# PLAN COMMISSION

Wednesday, April 10, 2024 – 6:30 PM

- B. Review/Recommendation: Plan Commission review & recommendation on a Conditional Use Application submitted by Kunes Appleton Properties for a proposed addition to the existing heavy vehicle sales and rental principal building located at 2615 West American Drive, specifically described as Tax ID #006-0341-01.

- C. Review/Recommendation: Plan Commission review & recommendation on a Site Plan Application submitted by Kunes Appleton Properties for a proposed addition to the existing heavy vehicle sales and rental principal building located at 2615 West American Drive, specifically described as Tax ID #006-0341-01.

# Approximate 2022 Gravel Display Area Expansion Outside 2017 Site Plan Approval

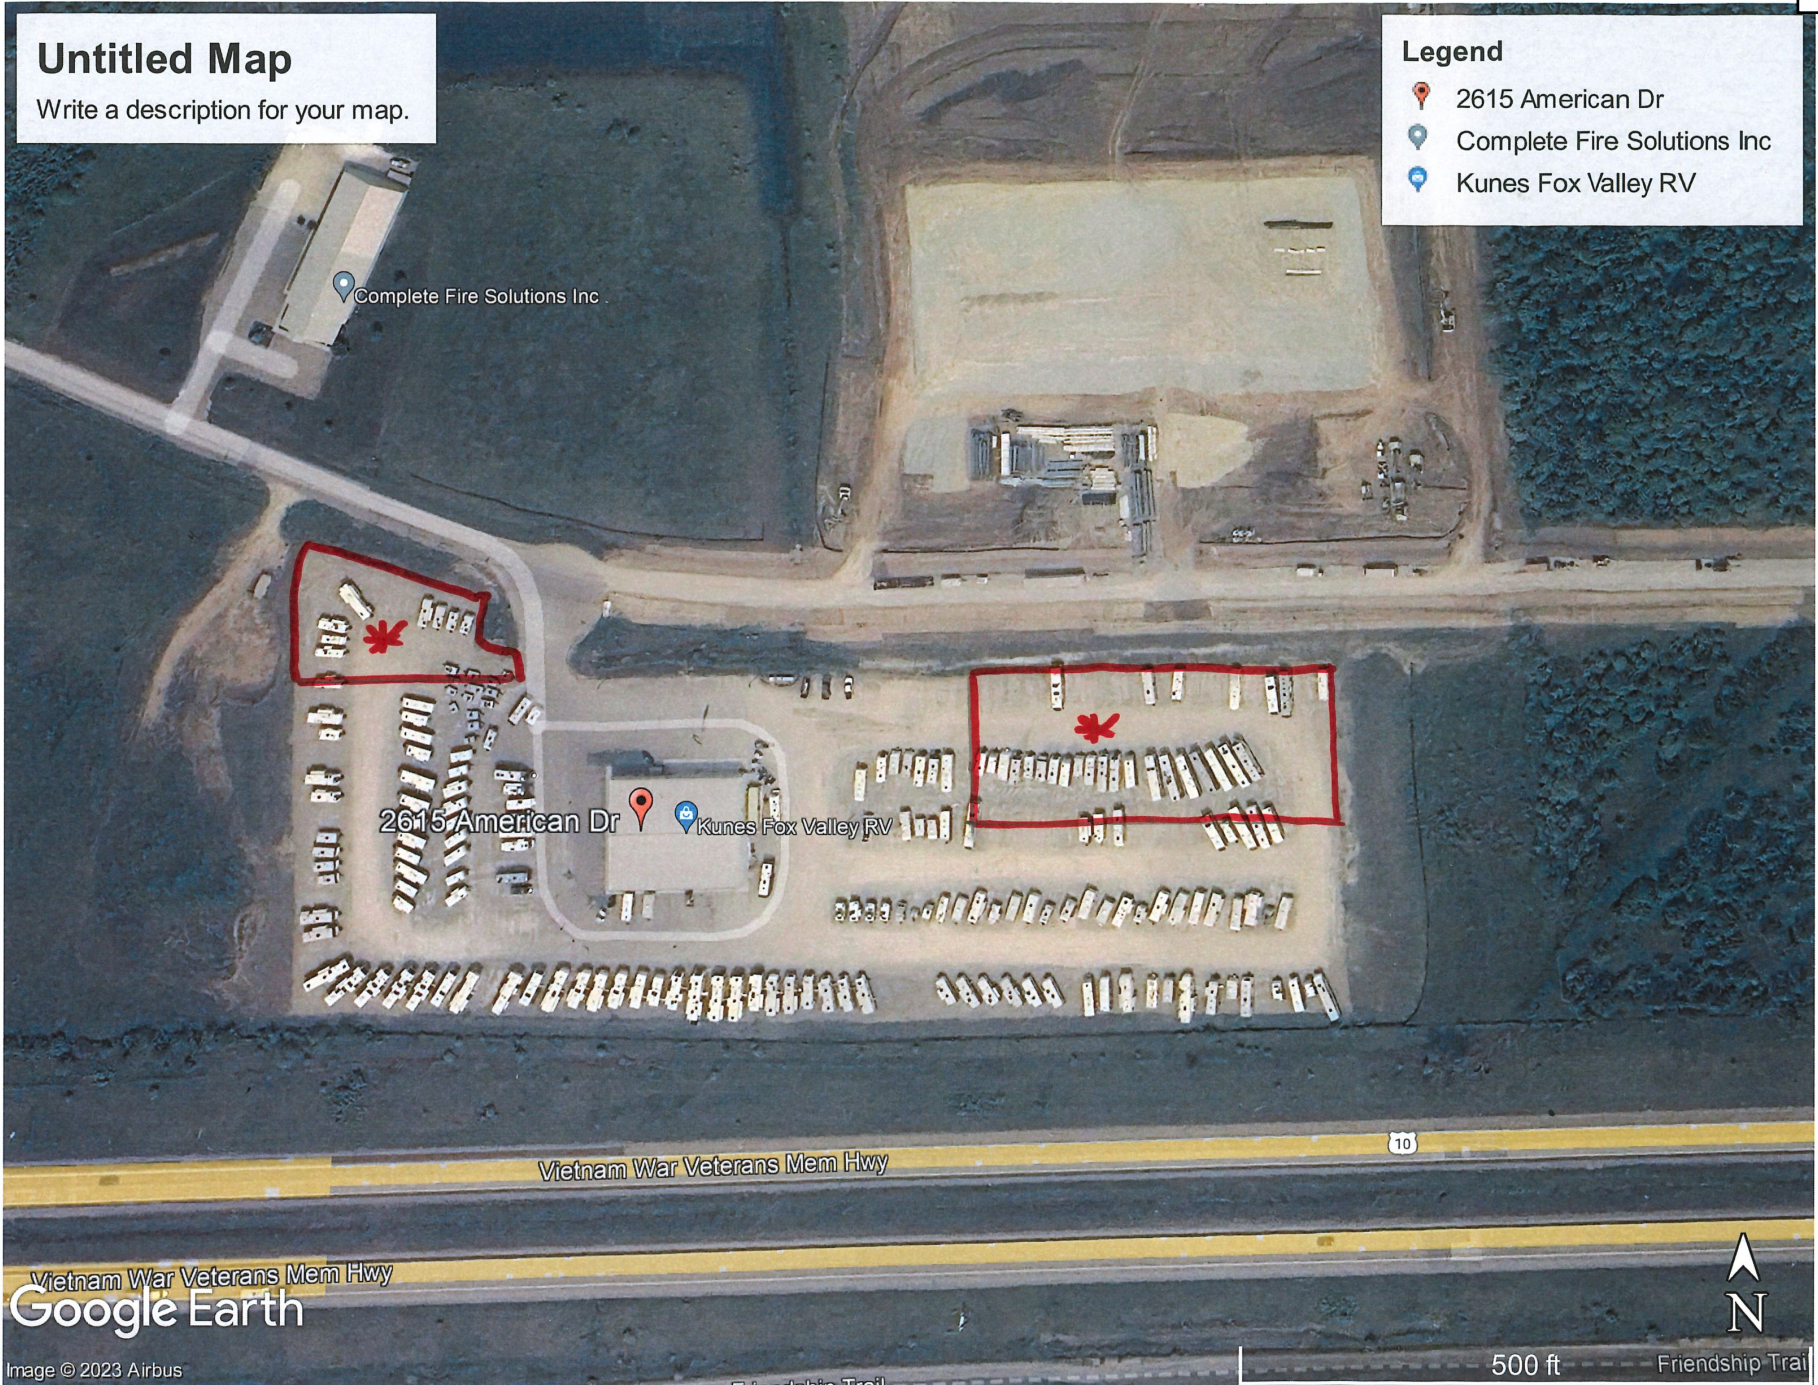
1. Gravel outdoor camper display area does not comply with the 2017 Site Plan Approval and the 25 ft. outdoor display area setback requirement per Sec. 9.08-291.
